Assessing the Impact of Metro West

Originally published on <https://jedsetter.com/assessing-the-impact-of-metro-west/>

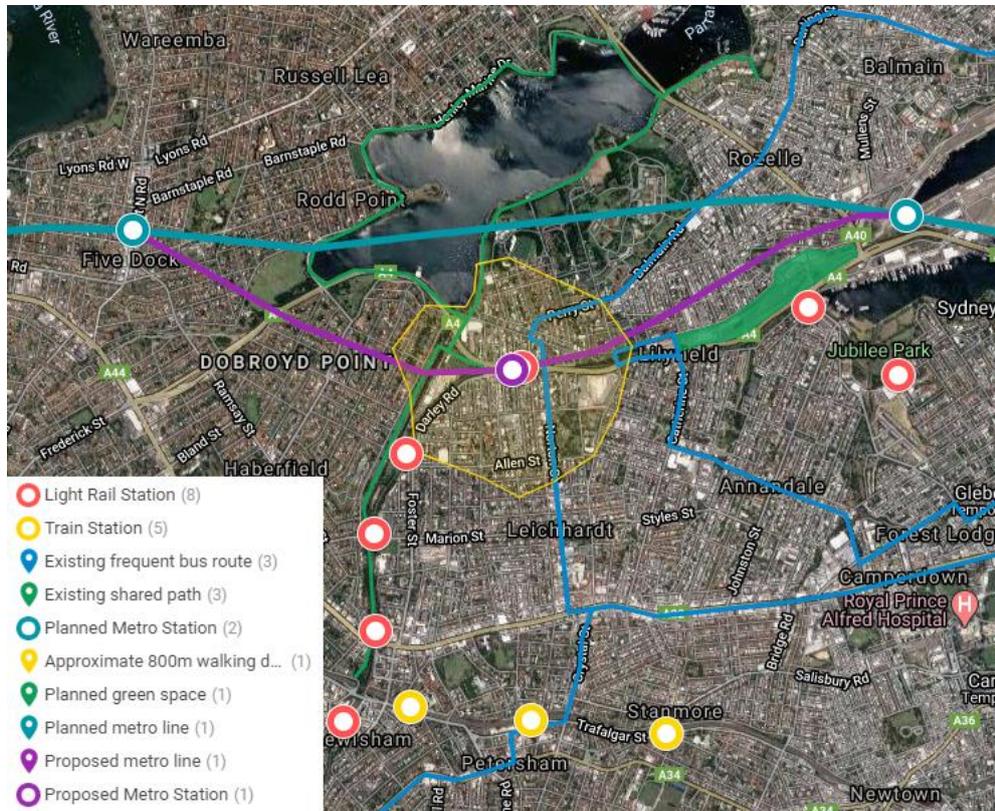
The project's stated goal of integrating with existing transport networks is not being fulfilled due to a missing interchanging with the existing L1 Inner West Light Rail line between Dulwich Hill and Central. Rozelle Bay Light Rail Station is only 700m from The Bays station. Close, but far too far for a convenient interchange.

A better alternative would be a new metro station at Leichhardt North to interchange with the light rail. The current Dan Murphy's site is immediately adjacent to the existing light rail station and would be perfect for a new metro station, nestled in a medium density mixed use neighbourhood that lacks good, direct public transport access to Sydney CBD or Western Sydney. It would dramatically increase the utility of the Inner West Light Rail line by bringing the areas of significant high density development in Lewisham and Dulwich Hill into the Parramatta and CBD 30 minute cities. It would relieve congestion on the light rail line and increase capacity due to eastbound passengers disembarking at Leichhardt North, freeing up room for those boarding at Lilyfield, Rozelle Bay, Jubilee Park and Glebe.

Metro for Silverwater

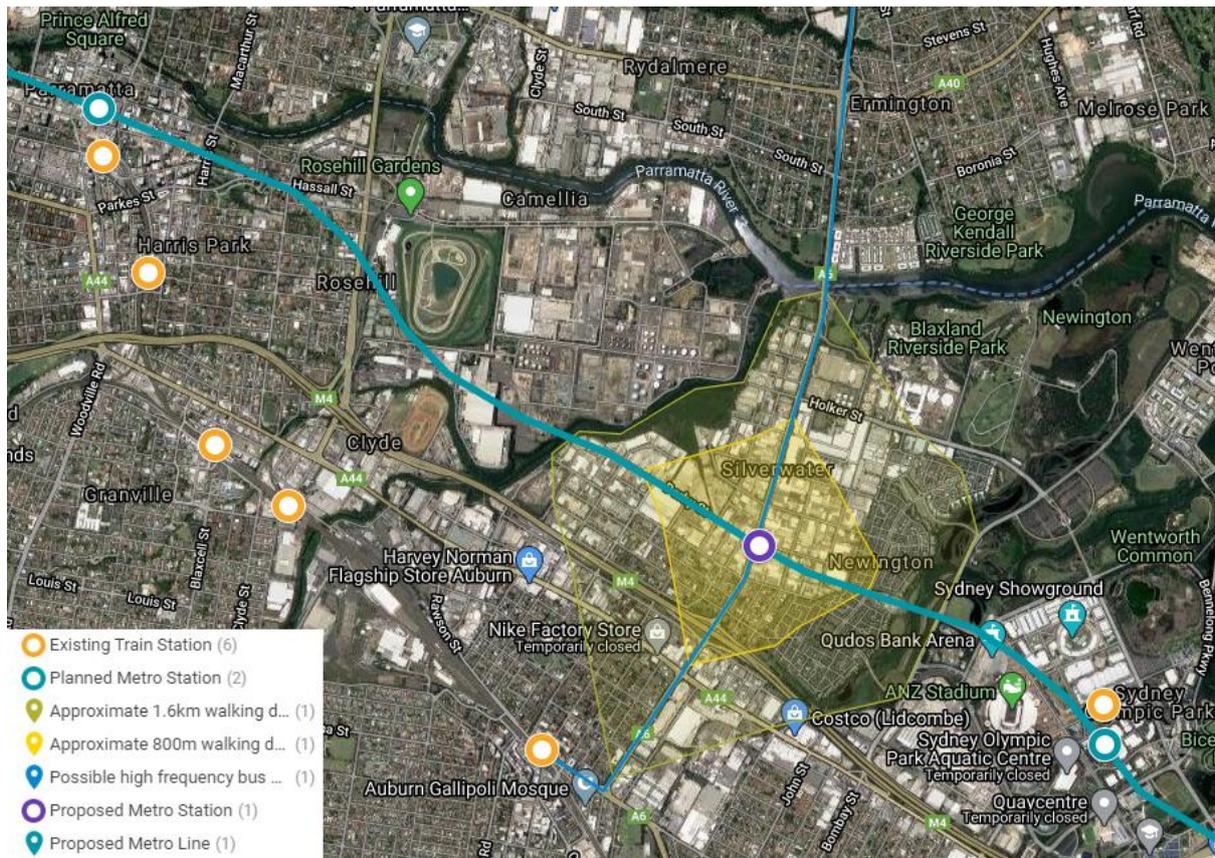
The other noteworthy area that is served by the metro alignment but not by a station is in Silverwater.

A station at Silverwater would require no alteration to the metro alignment as planned, in fact there's a ventilation and emergency exit point included in the EIS on the corner of Silverwater Road and Derby Street that could be expanded to include a new station.
